AGENDA
CITY OF BENBROOK
PLANNING AND ZONING COMMISSION
THURSDAY, SEPTEMBER 8, 2016

| DATE: | REFERENCE NUMBER: | SUBJECT: | PAGE: |
|---|---|---|---|
| **September 8, 2016** | **S-16-02** | **Extension of the Preliminary Plat of Benbrook Field Addition** | **1 of 3** |

**REQUEST:** Extension of P-10-01 Preliminary Plat of Benbrook Field Addition

| DATE: | REFERENCE NUMBER: | SUBJECT: | PAGE: |
|---|---|---|---|
| **July 8, 2010** | **P – 10 – 01** | **Consider Preliminary Plat Benbrook Field Addition** | 1 of 8 |

# BENBROOK FIELD
# PRELIMINARY PLAT
# JULY 8, 2010

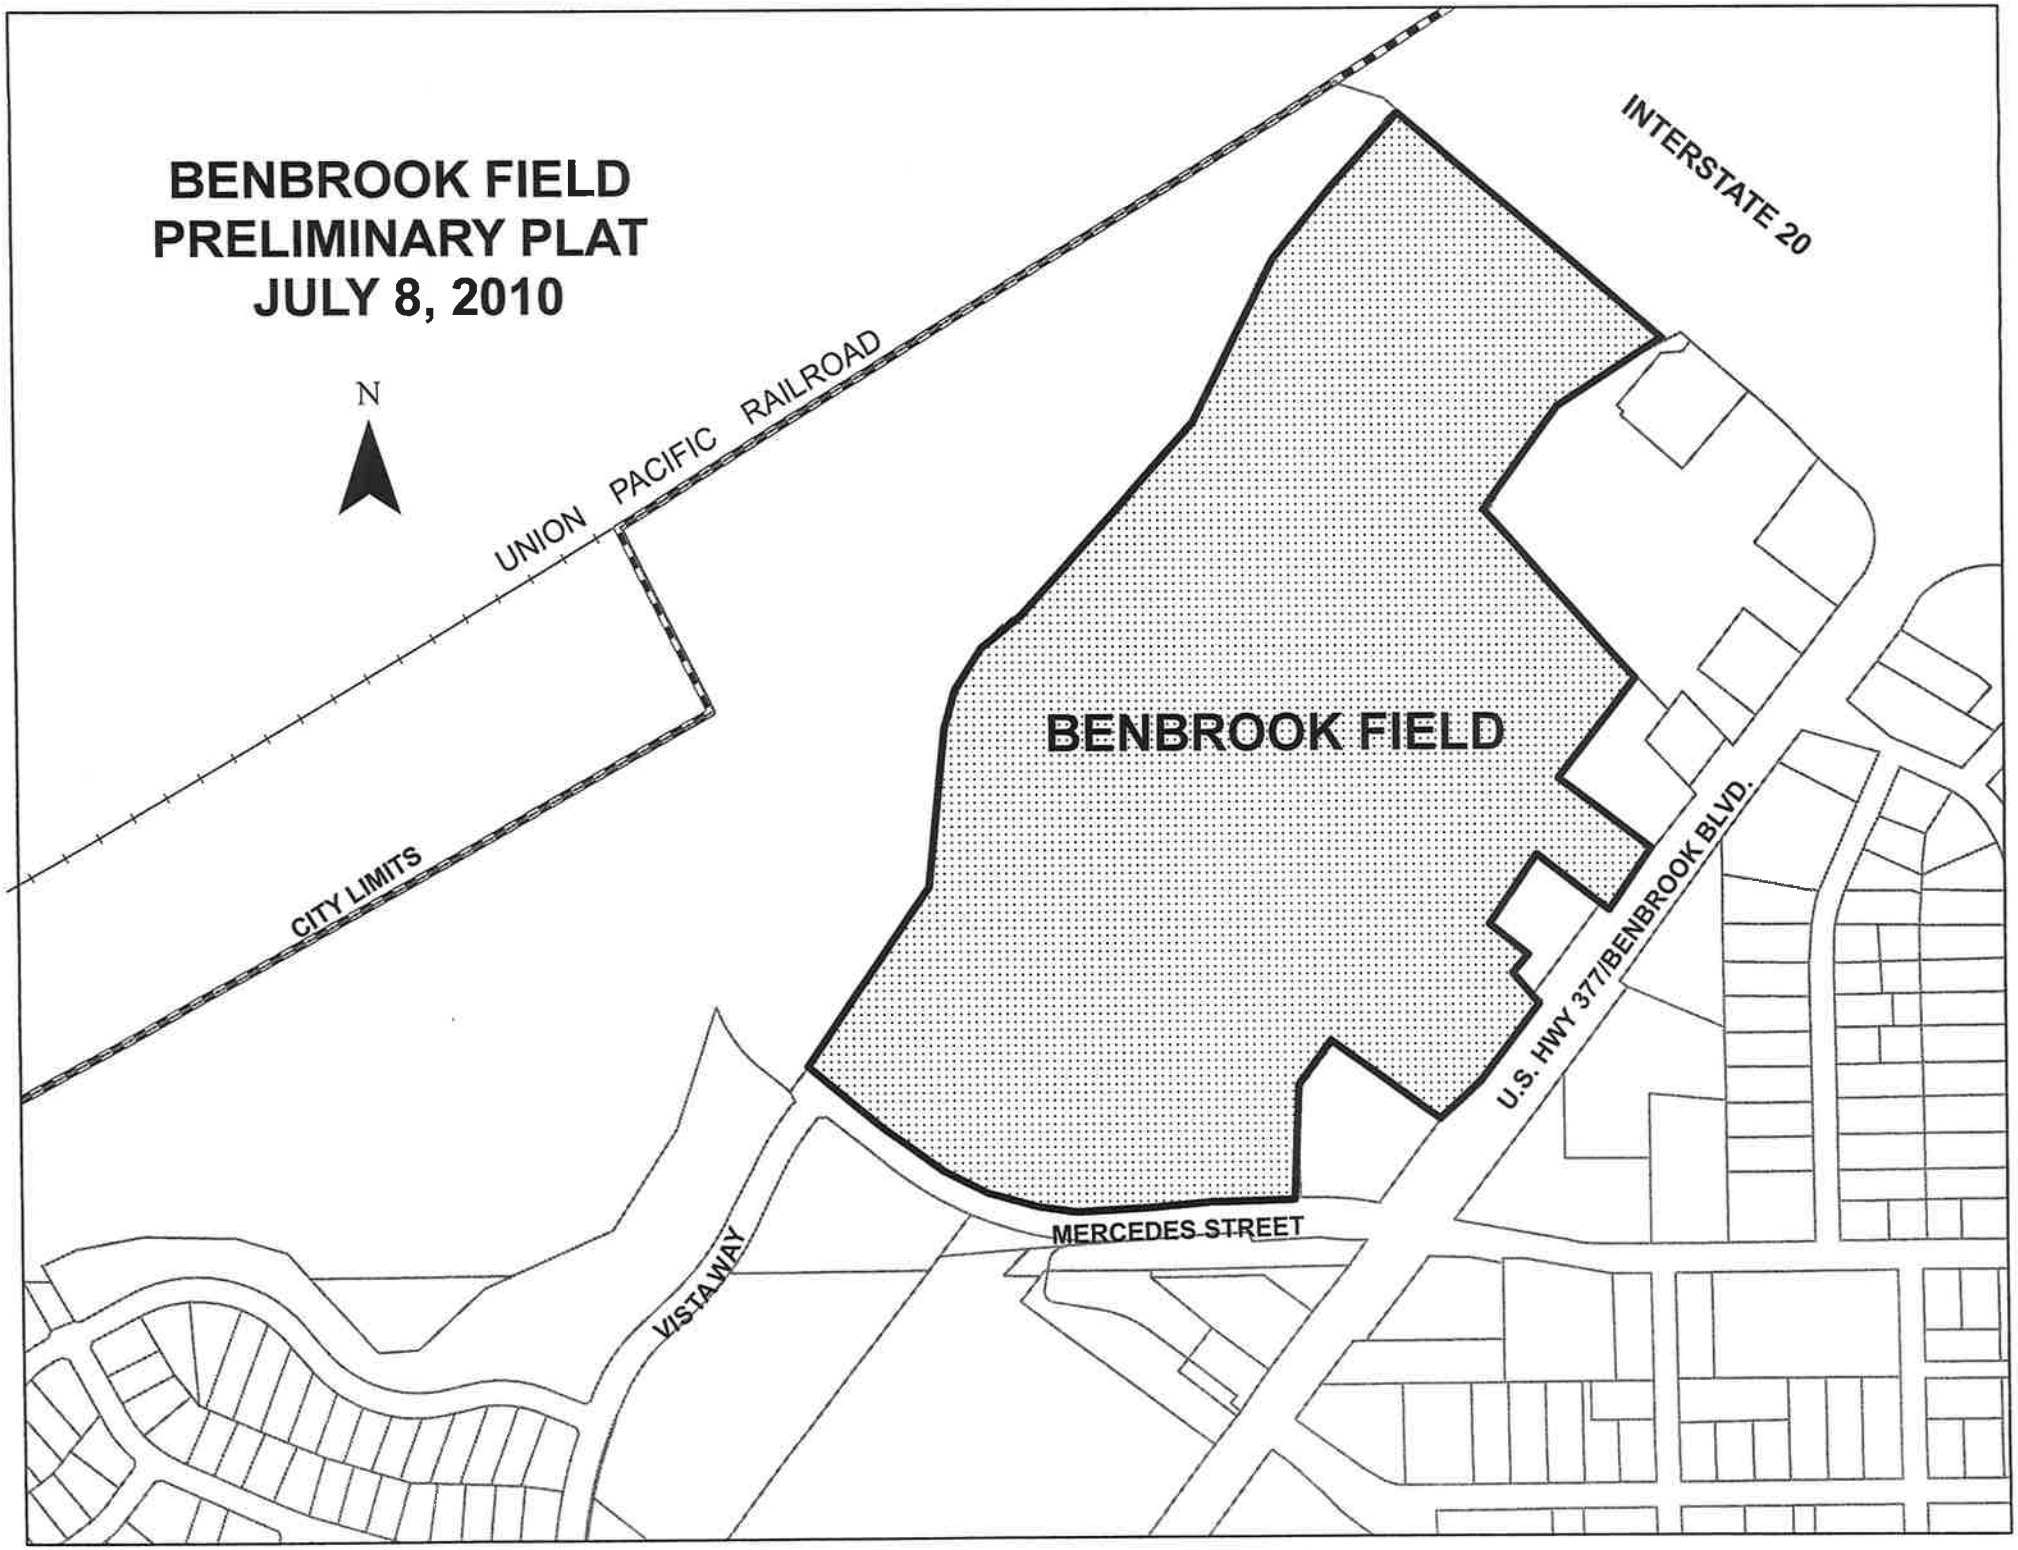
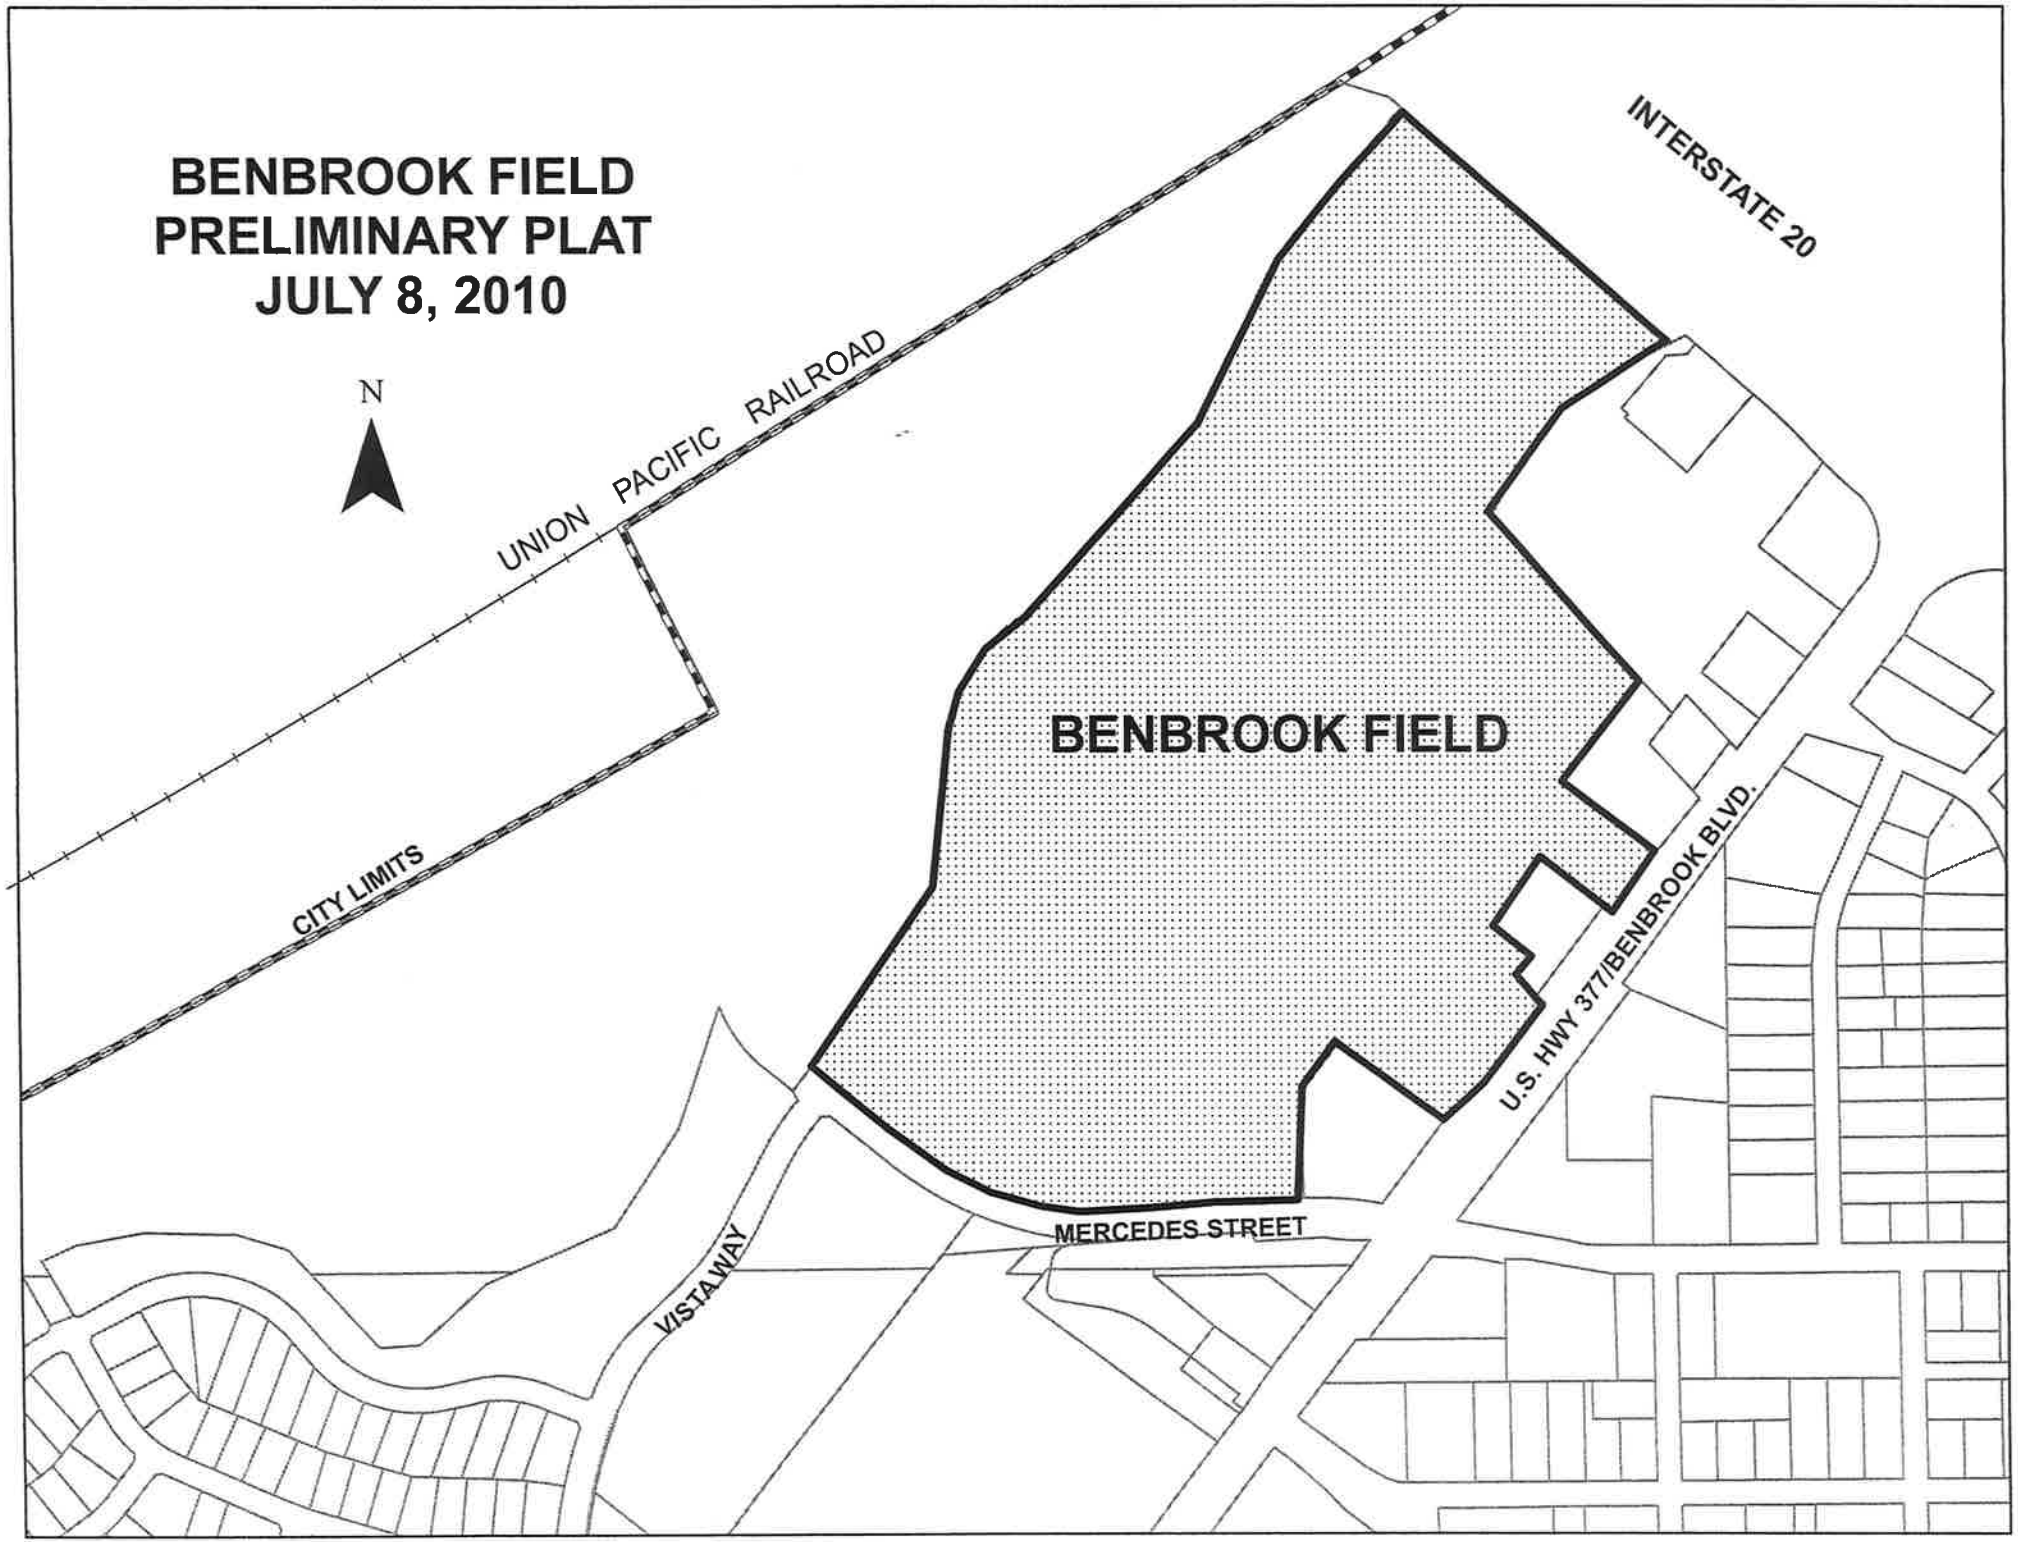
The City Planning Staff has reviewed the revised preliminary plat submittal and offers the following:

1. The P–10-01 preliminary plat is a revision of the P–07–02 preliminary plat considered by the Commission on July 12, 2007. The 2007 plat included the extension of Vista Way from Mercedes Street to the Loop 820 eastbound frontage road (in compliance with the Master Thoroughfare Plan, 7.3.4 of the Comprehensive Plan) and a new street, Benbrook Field Drive, connecting Benbrook Boulevard with the extension of Vista Way (in compliance with the 2004 Preliminary Plat approval for the overall project and 16.28.030, 2 Block lengths of the Subdivision Ordinance).

The configuration of the "D-PD" and "HC-PD" zoning district patterns was based on the location of Vista Way on the 2007 preliminary plat. With the revised location of Vista Way on the June 2010 preliminary plat, a 30-foot wide approximately one-acre strip on Lot 1, Block 5, will need to be rezoned from ""HC"-PD" to "D-PD" and an approximately 0.8-acre portion of Lot 2, Block 7 will need to be rezoned from "D-PD" to "HC-PD" to have the zoning pattern conform with the P-10-01 lot pattern. The preliminary plat submittal incorrectly labels these areas as "dual zoned," when in fact they are split zoned. The rezoning adjustment is not part of the current preliminary plat consideration but should be accomplished prior to final plats of the affected lots.

4. The preliminary plat includes the proposed Benbrook Field Drive, with a 60-foot wide, 230-foot long public right-of-way dedication that includes a 100-foot Diameter Turnaround area. A 50-foot building line in a concentric configuration should be added around the turnaround portion of street right-of-way on Block 1, Lot 1 and Block 2, Lot 1.

Additional right-of-way dedication at the Benbrook Field Drive and Mercedes Street intersections (generally 20-foot by 20-foot pedestrian refuge areas) will be required to accommodate the enhanced intersection treatments proposed in the Benbrook Boulevard Master Plan.

12. The required sidewalks and required street trees along Benbrook Boulevard can best be addressed with escrow of funds by the developer to enable a more consistent landscape and sidewalk treatment along the overall length of the upcoming TxDOT highway expansion project in conformance with the Benbrook Boulevard Master Plan. Funds are proposed to be escrowed for the overall Benbrook Boulevard frontage with the final platting of each lot with Benbrook Boulevard frontage. Sidewalks and curb and gutter along Benbrook Boulevard should also be deferred and addressed with escrowed funds.

13. A Tree Survey of existing trees was submitted with the previous P–07–02 preliminary plat and remains valid but did not include a mitigation plan for replacement of trees that are proposed to be removed. Tree mitigation provisions should be in accordance with the "PD" Zoning Ordinance Number 1239 provisions. Tree mitigation provisions should be separate from landscape and buffer yard provisions of the "PD" Zoning Ordinance.

17. The most significant aspect of the P-10-01 preliminary plat involves the extension of Vista Way in accordance with the Comprehensive Plan. Normal circumstances require all associated street, and other infrastructure construction with final platting of a single phase development. With phased final platting construction of all streets and infrastructure are required to and through all lots within each particular phase of a development. An acceptable configuration for the extension of Vista Way is shown on the plat.

With lots proposed to be "final platted individually in no particular order", provisions for the construction of Vista Way are proposed with a Vista Way Implementation Plan described on the P-10-01 plat under "Vista Way Implementation Notes" to provide for the design and construction of Vista Way. The implementation notes describe proposed funding of Vista Way with final platting of a collection of nine lots. The implementation notes cite five lots to be final platted with no funding obligation for Vista Way construction.

2. Is the intention to provide iSWM™ requirements for the entire plat or will each lot be required to provide their own?

2. Show section of access pavement. Will access be curbed?

1. As per discussions with Dunaway Associates on June 8, 2010, please add a 20-foot Utility Easement along the east side of Benbrook Field Drive to connect to the proposed Utility Easement north of the Jack-in-the-Box property.

2. Please change the note at the existing meter vault on the west end of the properties to: "Existing temporary meter station to be taken out of service." At the new meter vault location, please change the note to: "Install permanent meter station in existing meter vault."

It is recommended that the Planning and Zoning Commission approve the Revised Preliminary Plat of Benbrook Field Addition, June 2010(P-10-01) subject to:

5. Submittal of a tree mitigation plan based on the tree survey submitted in 2004, along with an implementation schedule,

6. Street trees and sidewalks along Mercedes Street, Vista Way and the I-20 frontage road at final platting. Street trees and sidewalks along Benbrook Boulevard in accordance with the Benbrook Boulevard Master Plan with funds escrowed with the first final plat fronting on the highway,

8. Building lines to conform with "D" or "HC" District Height and Area Regulations except as they may have been altered by the Planned Development zoning (Ordinance Number 1239), and parkland dedication in accordance with provisions of the Subdivision Ordinance, with final platting of the "D-PD" zoned property,

10. Construction of Benbrook Field Drive, with signalization, to be initiated with the final plat of Lot 1, Block 1; Lot 1, Block 2, or Lot 2, Block 2.

# A PRELIMINARY PLAT OF
# BENBROOK FIELD
(PD Zoning Parcels 2-5 Combined)
Being a 46.27 Acre Tract out of the H. Covington Survey, Abstract #257; and the J. Stephens Survey, Abstract #1494.

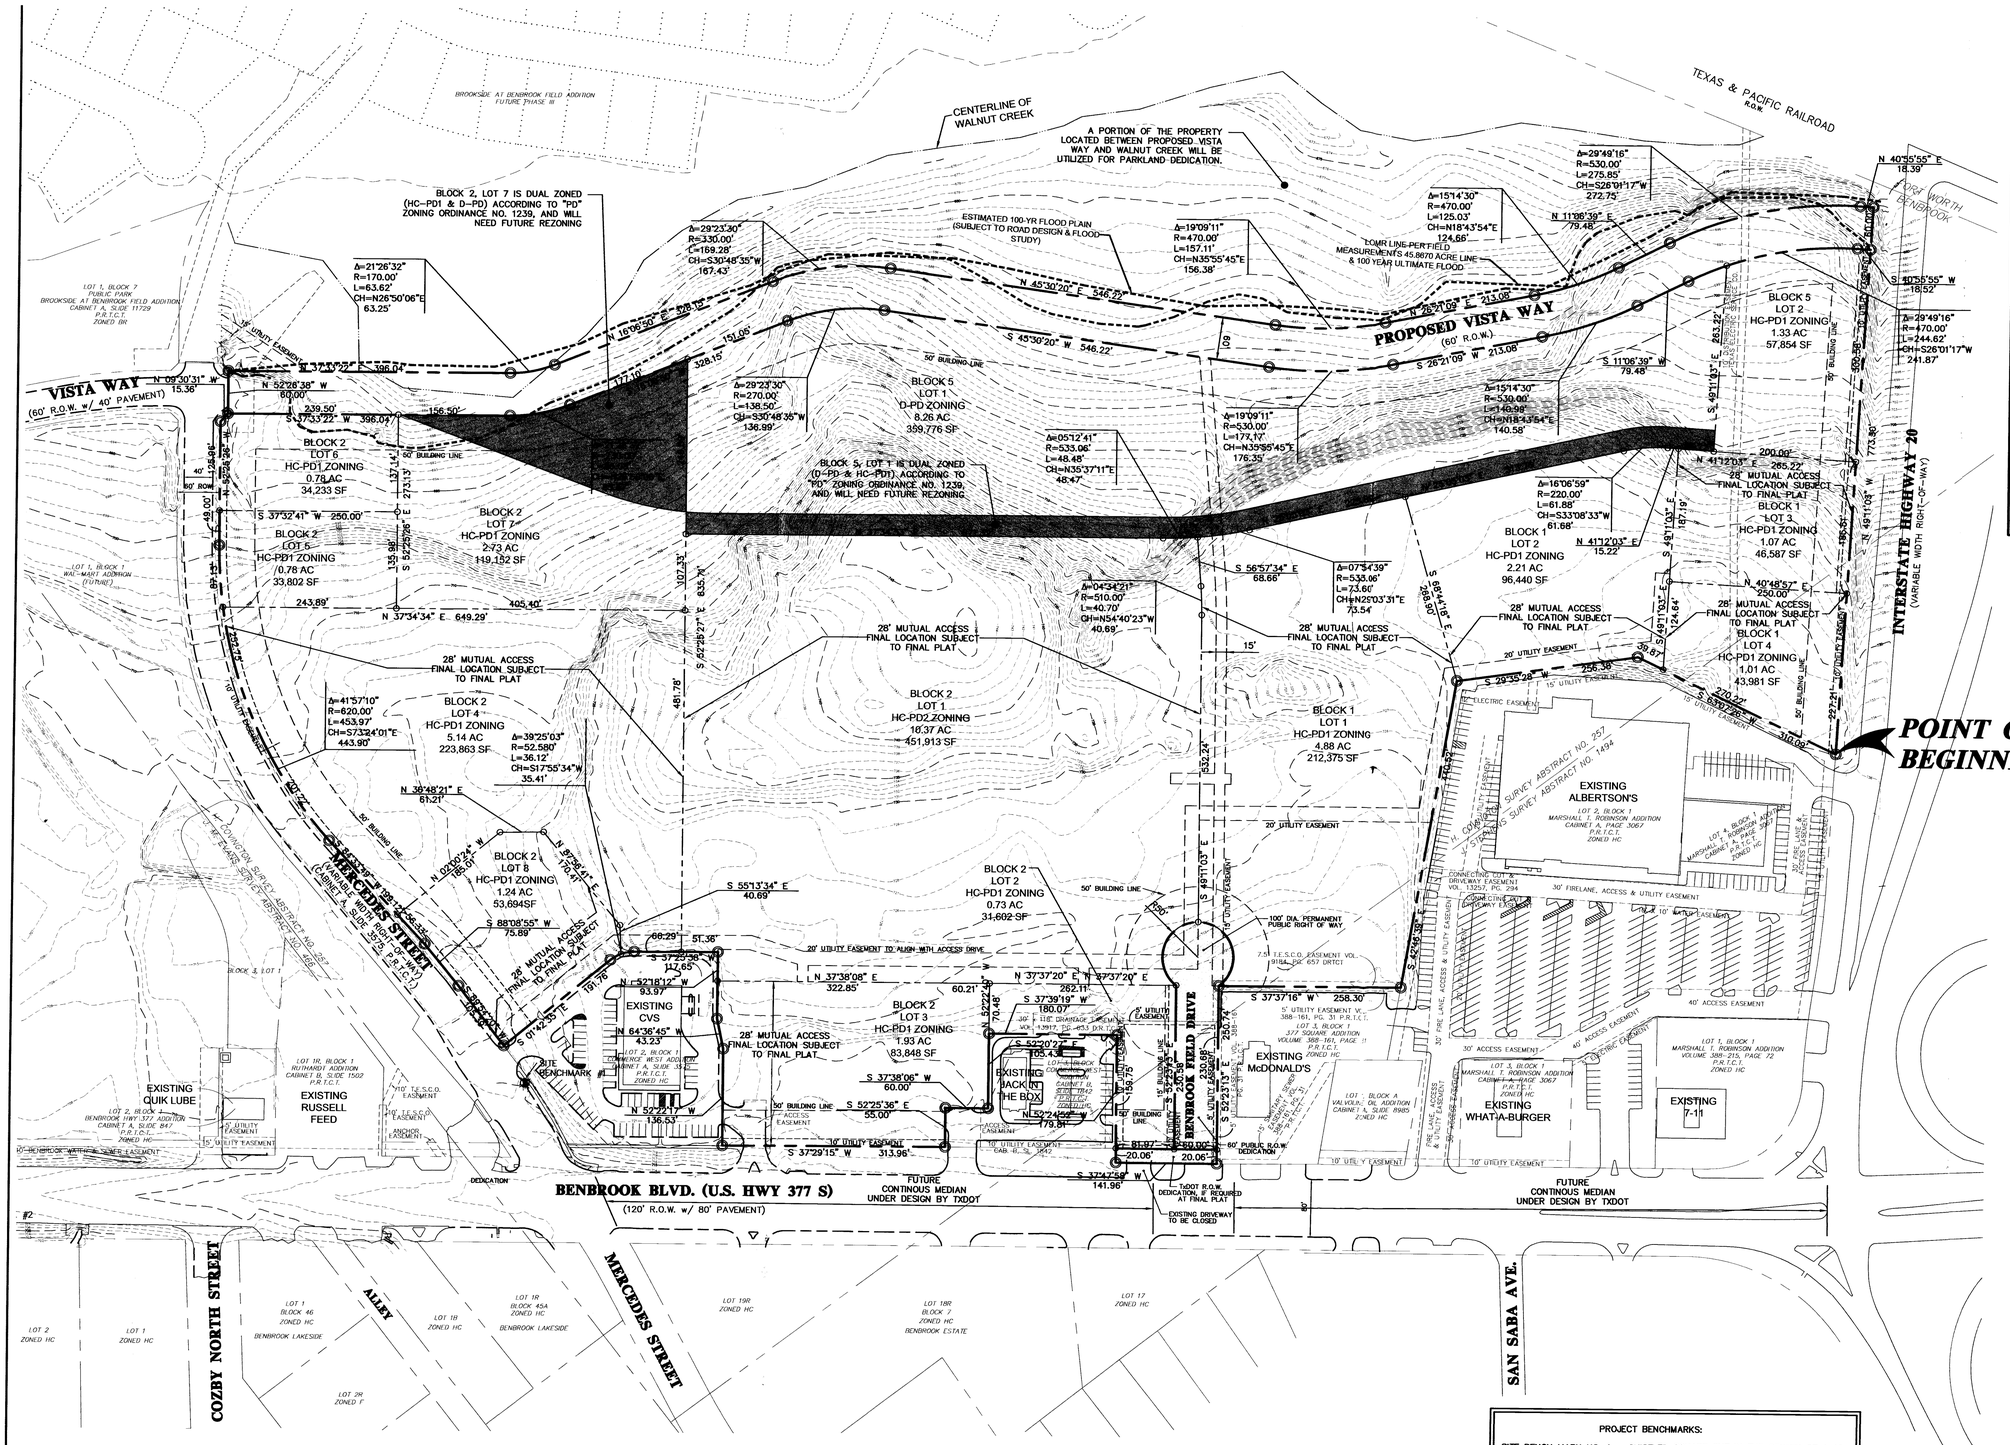
Mr. Gallagher said the Benbrook Water Authority notes that an additional 20-foot utility easement is required along the east side of Benbrook Field Drive for connection to the proposed easement north of the Jack-in-the-Box property. The identification reference to the existing meter vault needs to be corrected and the location and description of the new meter station added. A fire hydrant location shown conflicts with the Benbrook Field Drive turnaround and should be relocated.

Mr. Hafer said a 28-foot mutual access private drive throughout the development is not the best means to move traffic in, out and within the development. He said the interconnected private drives do not seem to be consistent with the City's Subdivision Ordinance and Comprehensive Plan. Chapter 16.28 of the Subdivision Ordinance states that "each lot shall abut on a dedicated public street or an approved private street" and there is no mention of providing access via mutual access private drives.

3. Recommendation No. 10 – Change to signalization will be installed when warrants are met as required by TxDOT
